From: Tsui Ling Chung <[REDACTED]>
Sent: 2025-11-05 Wednesday 15:54:23
To: tpbpd/PLAND <tpbpd@pland.gov.hk>
Cc: [REDACTED]
Subject: A/YL-SK/421 補充文件
Attachment: A_YL-SK_421 回應渠務署、地政總處、運輸署意見.pdf; A_YL-SK_421 回應部門意見.pdf; A_YL-SK_421 排水建議.pdf

申請編號：TPB/A/YL-SK/421

回應部門意見

提議渠務報告 (Proposed)

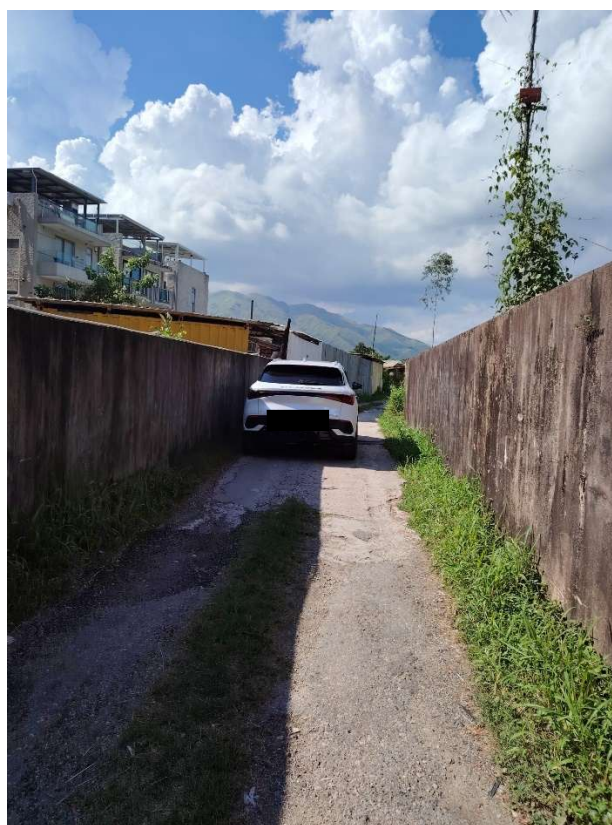
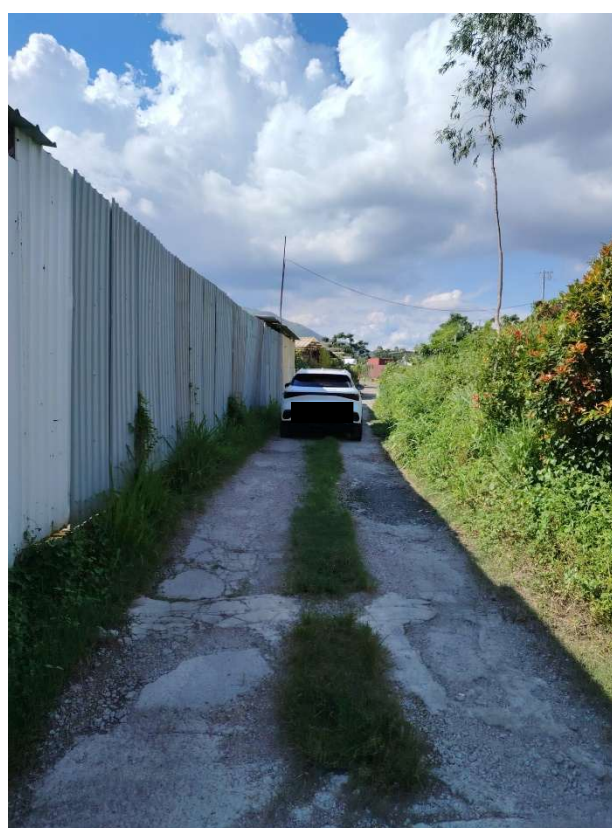
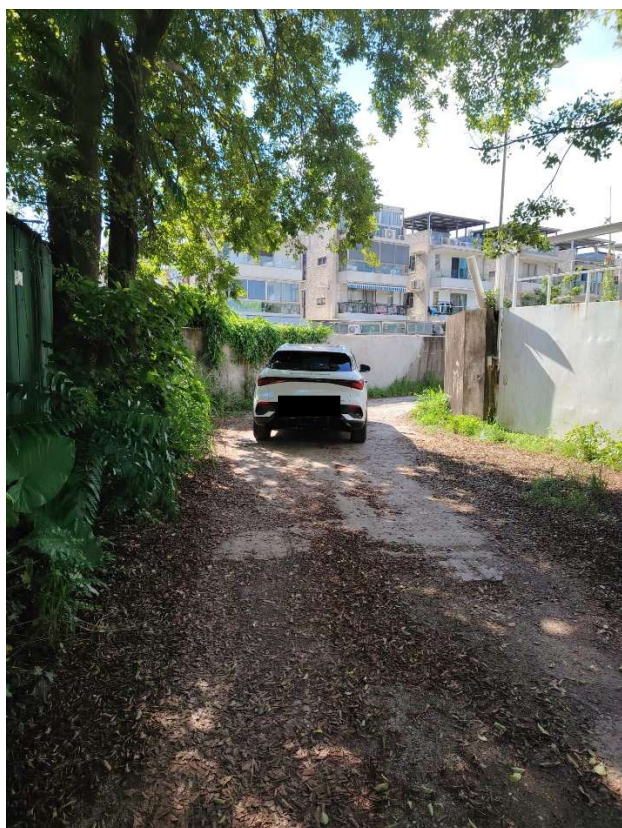
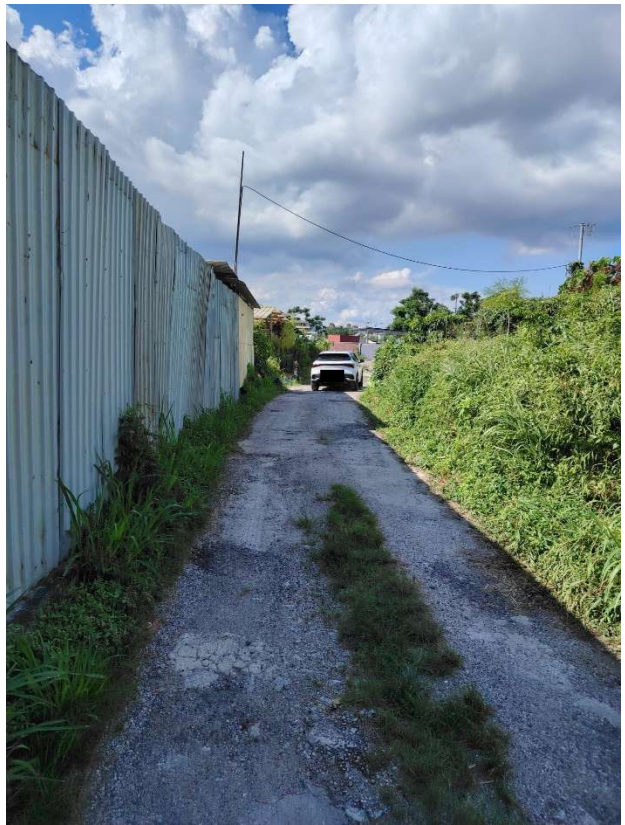
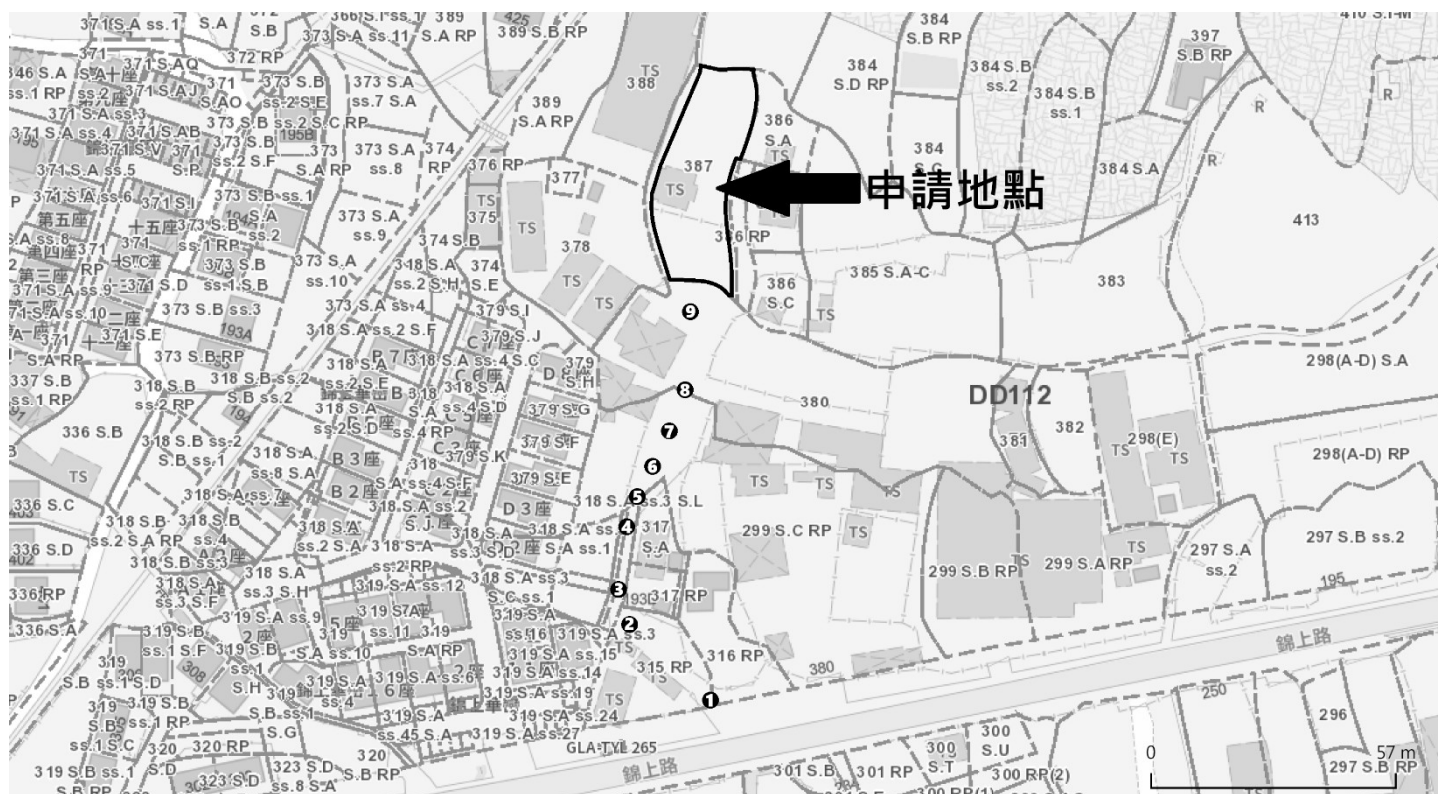
(a) 車輛能在申請場地及鄰近路段順暢行駛，請參考以下圖片：
